**CROWAG Phase 2 Submission  
Activity Centres – Draft Maps – 22<sup>nd</sup> March 2026.**

Figure 1. An active transport link between Blackburn and Nunawading.

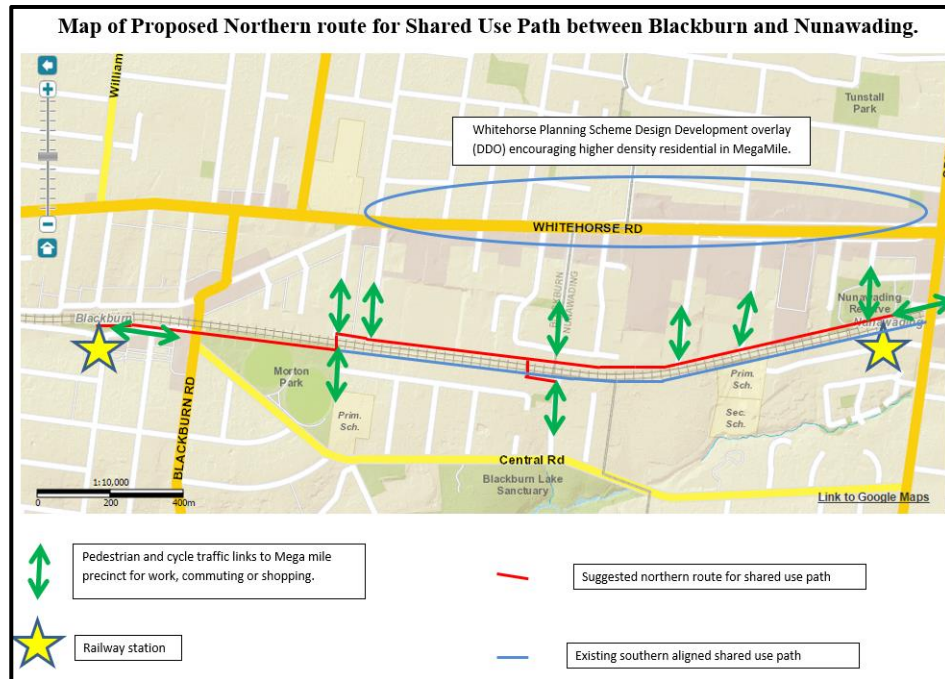
- **Inclusion of an active transport link** along the northern side of the rail corridor between Blackburn and Laburnum and Blackburn and Nunawading that would link the dead-end streets from Whitehorse Road, opening car free access to stations and commercial businesses.

Figure 3. DDO8 E and F providing a sensitive interface. Should be amended to outer and inner catchment.

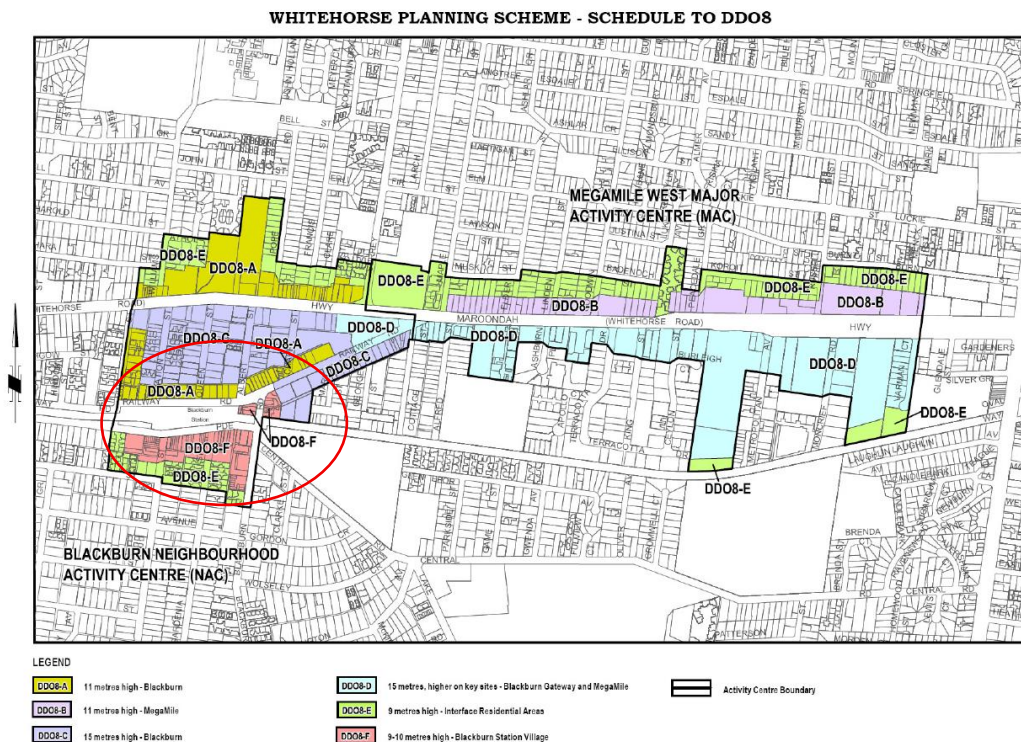
- **The proposed 12 storey building wall in Blackburn Village’s heart - South Parade** will cast extensive and unbroken shadows on the residential area to the south, reaching almost to The Avenue. The affected homes will see no sunshine during the depths of winter and those closer to the tall buildings will suffer loss for most of the year. As well outflow of lighting onto adjacent sensitive landscapes will impact on Blackburn’s night wildlife and adjacent residents for a long distance south.

**Reassigning of South Parade from core to inner catchment with a stepped heights from 6 storeys on South Parade, to 4 storeys on properties behind, transitioning to 3 storeys in the Outer Catchment** — would maintain pedestrian scale, protect the established street rhythm, and still represent a very significant uplift from current controls. It would also better align with the existing DDO8 with preferred maximums of 9 –10m in this precinct.

- **Reassign South Parade, Blackburn from core to inner catchment with a stepped height from 6 storeys on South Parade, to 4 storeys on properties behind, transitioning to 3 storeys in the Outer Catchment** to protect the established street rhythm, and better align with the existing DDO8 which has preferred maximums of 9 –10m in this precinct.

Figure 4. Whitehorse Easy Ride Network. Plus, additional links in Yellow. All need upgrades to make commuter cycling safe and friendly.<sup>4</sup>

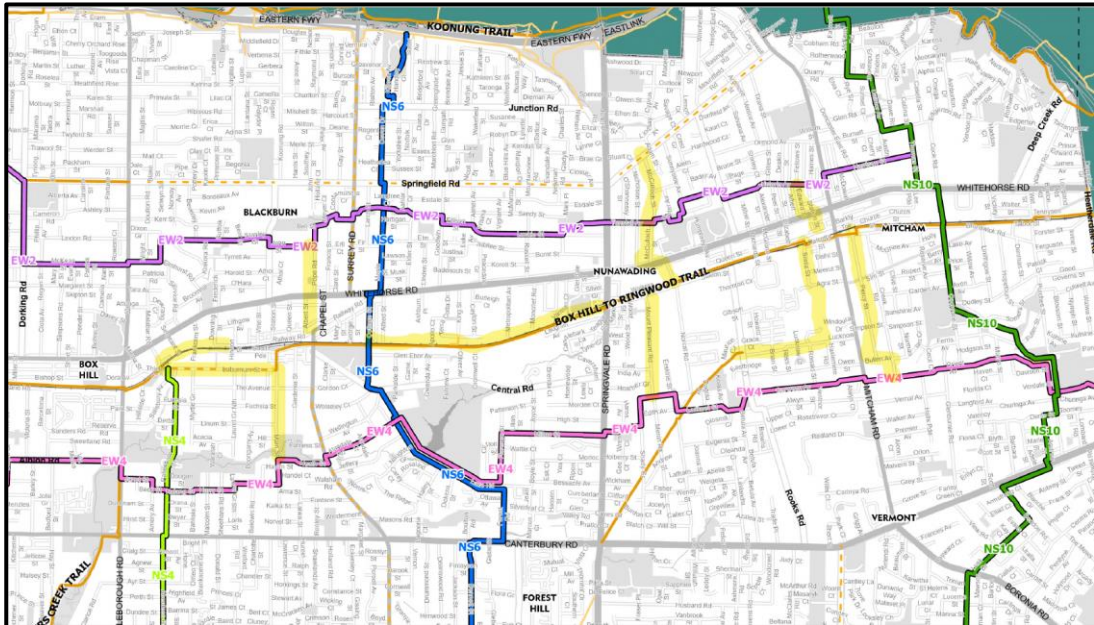
**Safe protected active transport links (highlighted in yellow) are required:**

- North along rail corridor between Dowling and Sergeant Street linking them to Blackburn and Laburnum Stations.
  - North along rail corridor between Blackburn and Nunawading Stations linking to side streets – Cottage, Alfred, King, Metropolitan Ave, Moncrief and Varman.

- Albert and Johns Street north of Blackburn Station.
  - Main street to Blackburn Station.
  - Laburnum Street joining Blackburn and Laburnum Station
  - Mount Pleasant Road to Nunawading Station

- McCulloch Street, Harvey Norman Lane to Nunawading Station
  - Lucknow Street, Reservoir Lane, Agra and Simla Streets to Mitcham Station.
  - Edward and Station Streets to Mitcham Station.

- Orient Ave, Creek Road, Bullen Ave, Percy Street to Mitcham station.
- **Improve pedestrian safety and accessibility through safe crossings over major roads and rail corridors.** Link and make safe walking and "active" access pathways connecting residential, commercial, industrial and public transport - particularly across major roads such as Whitehorse, Middleborough, Springvale, Mitcham and Blackburn Roads, all of which are major arterial roads that already have heavy traffic loads and will only become busier once NE Link is finished.
